Service Bulletin

BKSB-1018
Issue Date 7-7-03

Issue: Difficulty adjusting “Line to TX Audio Level” and “RX Audio to Line Level”.

Affected Models: LZA 2027 Tone Termination Panel

Figure 1 – Parts Placement

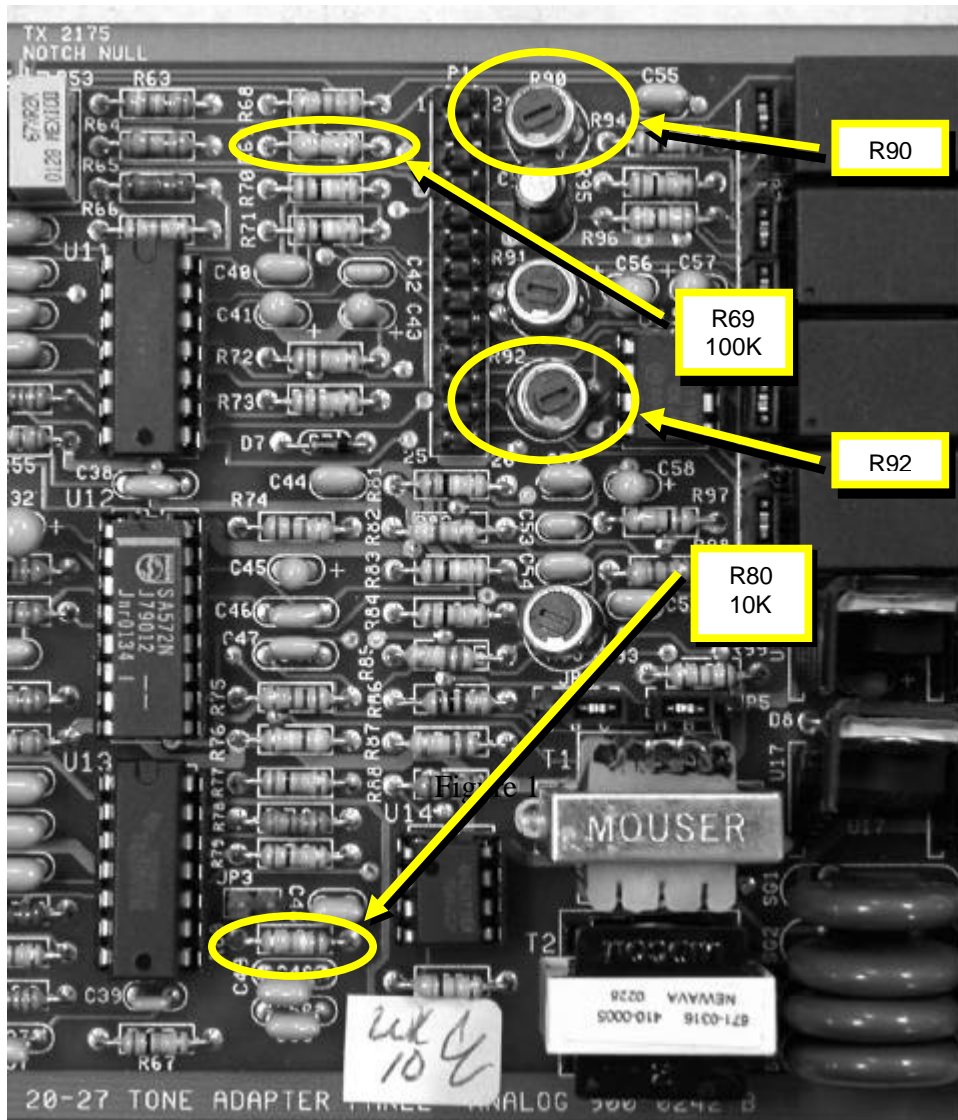
- a. Replace R69 with 100K (RELM p/n 4704-00104-032)
 - b. Replace R80 with 10K (RELM p/n 4704-00103-032)
3. If Technical Service Bulletin #1014 has not been implemented, it is recommended to do so now. Skip step 4.

4. If Technical Service Bulletin #1014 has been implemented, then do the follow adjustments (See Figure 1 for parts placement):
 - a. RX Audio to Line Level - While injecting a standard input signal from your RF generator (-60dBm RF, 3kHz wideband mode or 1.5 kHz narrowband mode deviation of 1kHz tone), adjust R92 until 0.24Vrms (-10dBm) is measured on the remote line.

- b. Line to TX Audio Level - While transmitting and modulating into the remote handset, adjust R90 until the deviation starts to limit just above 4kHz. Do not exceed 5kHz.
